# DP750/752/760/720/722/730 Firmware Release Notes

## FIRMWARE VERSION 1.0.21.31

### ADDED “ENABLE DND FEATURE”

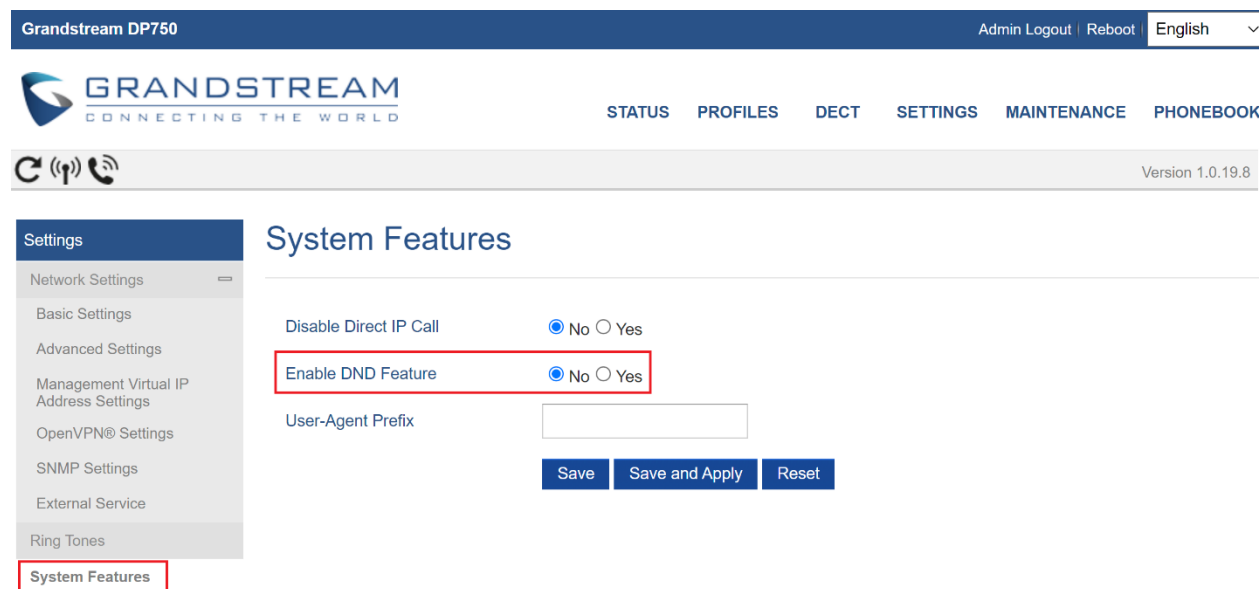
The default settings for “Enable DND Feature” is “Yes”, users can use DND feature in the Handsets.

When set to “No”, DND feature is disabled, users can NOT use DND feature in the Handsets. The Handset UI will show “Do Not Disturb” as “Disabled” when configure such settings in the Base Station UI.

## ENHANCED SECURTY WITH SSL MEDIUM STRENGTH CIPHER SUITES

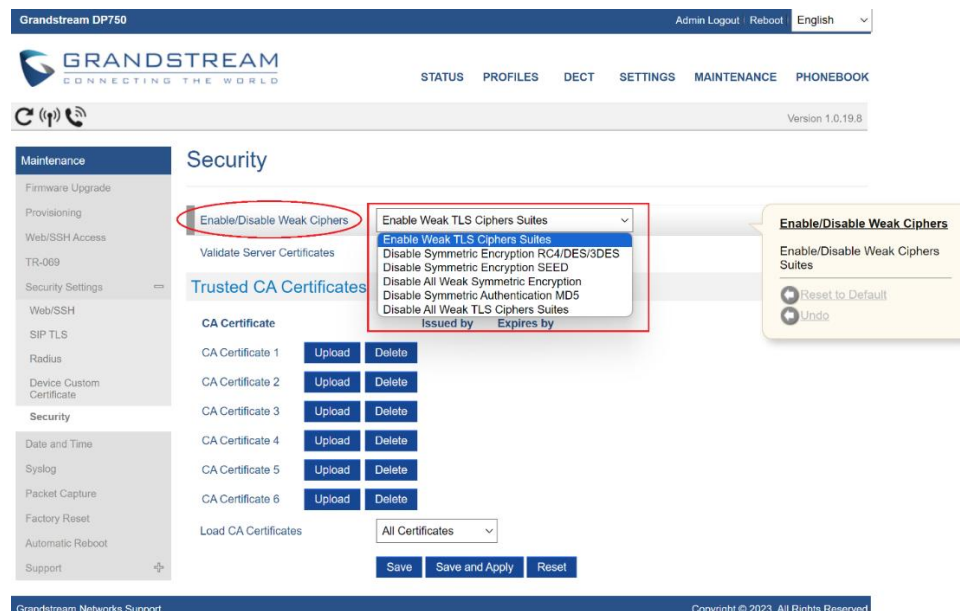
This feature allows users to choose different lever of TLS Ciphers Suites in the application environment.

## OPERATION FOR 3-WAY CONFERENCE

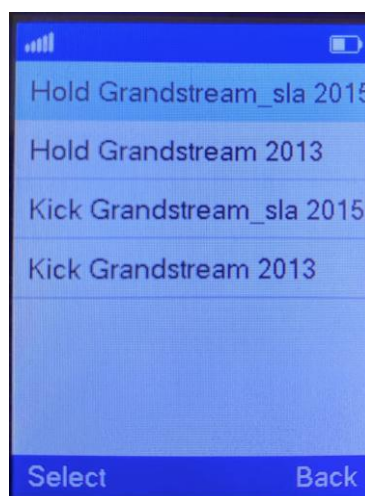
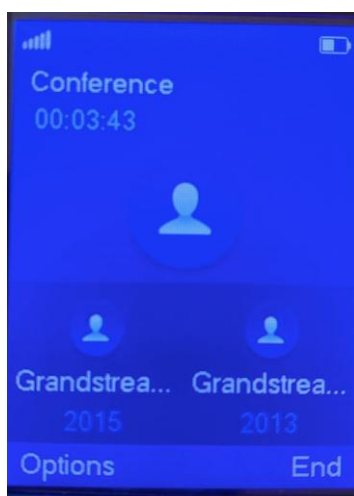
Since 1.0.17.3, if the handset bridged 2 calls into a conference, he now able to kick one of the participants without ending the whole conference, or he can also hold and unhold participants without kicking them off the call.
